Redhills Arterial Transport Network

Addendum to the 2020 Landscape and Visual Effects Assessment

March 2023

Version 0.3

Figure 4: NoR 1 After Design Change (Proposed North-south Arterial Corridor Alignment) Between Chainage 0-540 (Don Buck Road/Royal Road intersection) to just before Proposed Stream Crossing

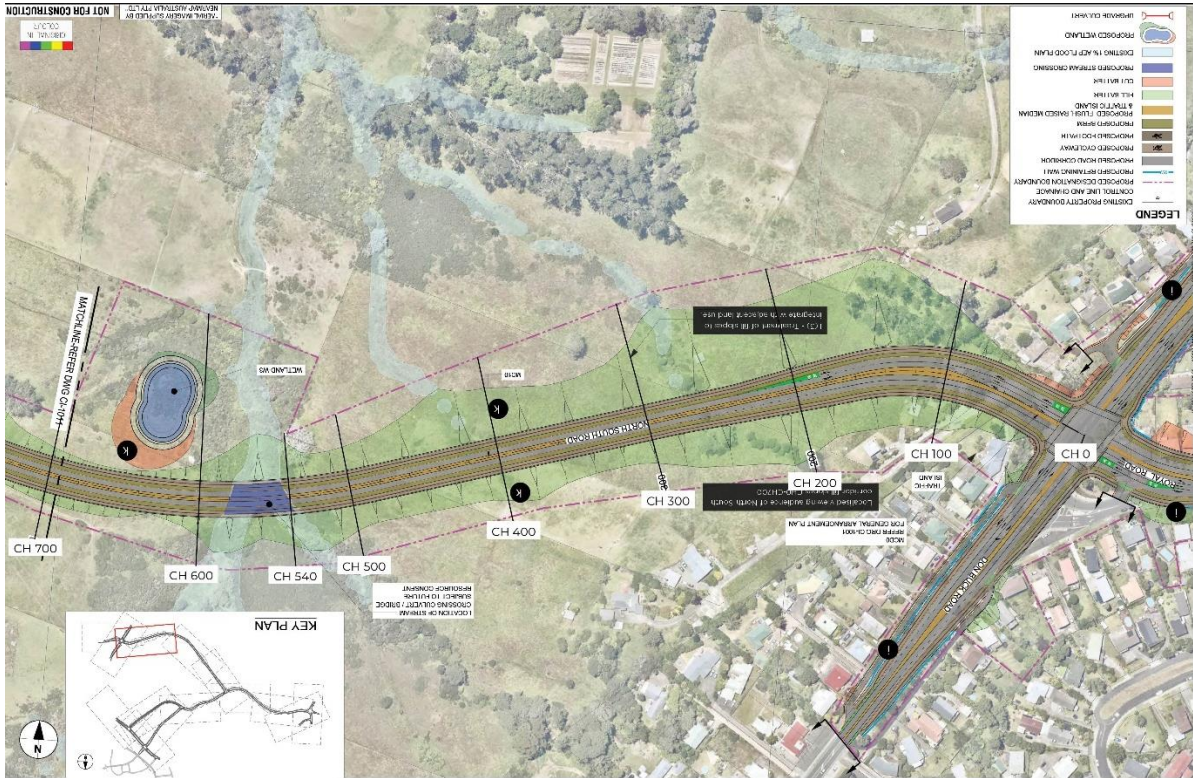
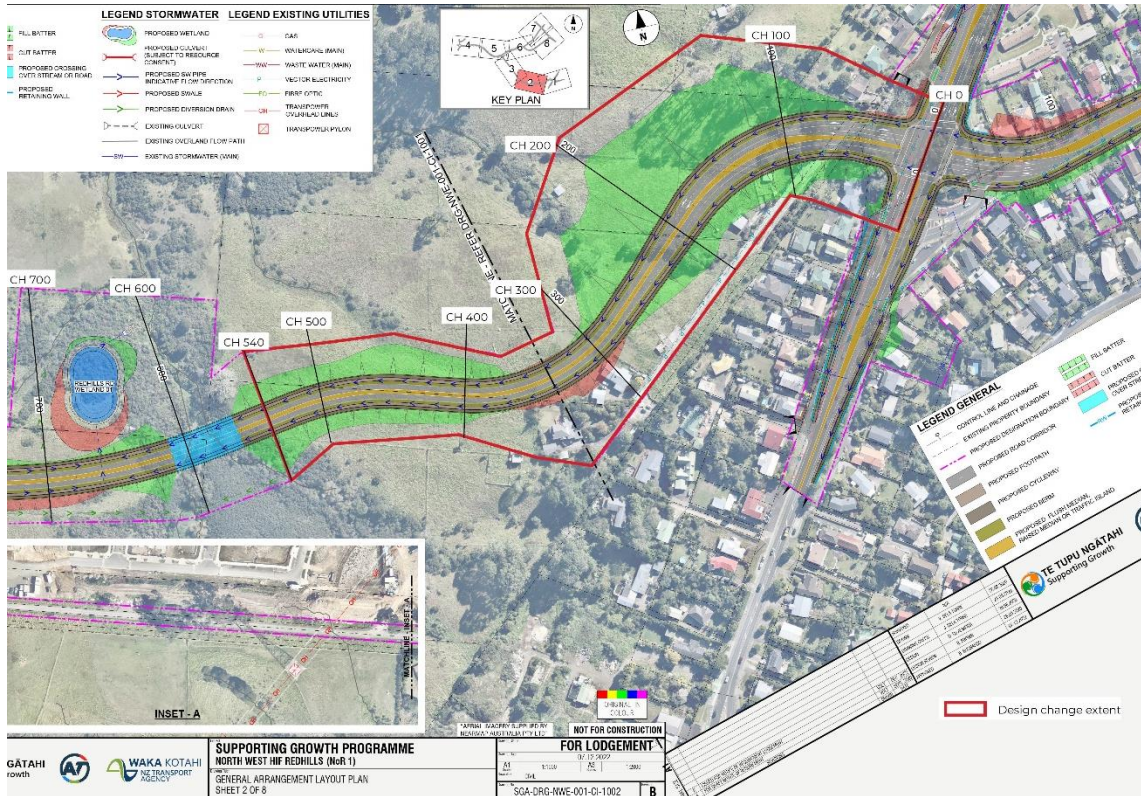
The original NoR1 designation boundary proposed a linear alignment of the north-south arterial corridor from Don Buck Road and Royal Road intersection to the proposed stream crossing at CH 0-560 (Map 15, Appendix 2 of the existing LVA). This alignment cuts across the landscape intersecting with fragments of terrestrial bush and ephemeral stream corridors before tying into the proposed stream crossing over the Ngongetepara Stream at CH 0-560. A significant extent of fill batter slopes on either side of the transport corridor are proposed, which overlap with the terrestrial vegetation and stream tributaries flowing into the Ngongetepara Stream (refer Fig 3).

The design change alters the route between Don Buck Road/Royal Road intersection to just before the proposed stream crossing at CH 0-540. This change proposal is documented in the Redhills Resource Consent drawings SGA-DRG-NWE-001-CI-1001 and SGA-DRG-NWE-001-CI-1002 (refer Fig 4). Refer Appendix 1 for reference drawings relating to the RATN.

The alignment now bends southwest from CH 0-100 to run along the boundary with residential properties on Don Buck Road, before bending back to intersect with the original alignment at CH 0-540.

The route will be more elevated when compared with the original alignment and shifts further away from the tributaries of the Ngongetepara Stream. This achieves a key objective of minimising adverse effects on the biophysical values of the stream system, which contribute to the natural qualities of the landscape. It also means that this section of the RATN will sit closer to natural ground level thereby reducing earthworks volumes and helping to facilitate future local road connections. Overall, the new alignment will significantly reduce the amount of fill batter slopes and reduce modification to the natural landform.

The design change brings the designation closer to some residential properties on Don Buck Road when compared with the existing LVA extents. This will result in some dwellings being removed, while others will be in closer proximity to the new transport route alignment. The properties affected, and a description of the change is set out in Table 2 below.

- Adverse effects on biophysical landscape values resulting from garden planting removal around homesteads at 456a and 458 Don Buck, at approximately CH 0-400 of the greenfield site. Refer to Figure 4.

The proposed north-south arterial transport corridor ties into the Royal Road intersection between 452 and 462 Don Buck Road (refer Figure 4). The original design proposes a steep section (8% grade) from the intersection before tying into the natural ground level. The design change proposes moderate fill batter slopes that would reduce the amount of fill when compared with the original design. While this still incurs a modification of the landscape, a gentler slope profile is created that is more sympathetic to the natural landform and would retain a greater degree of the site's natural character.
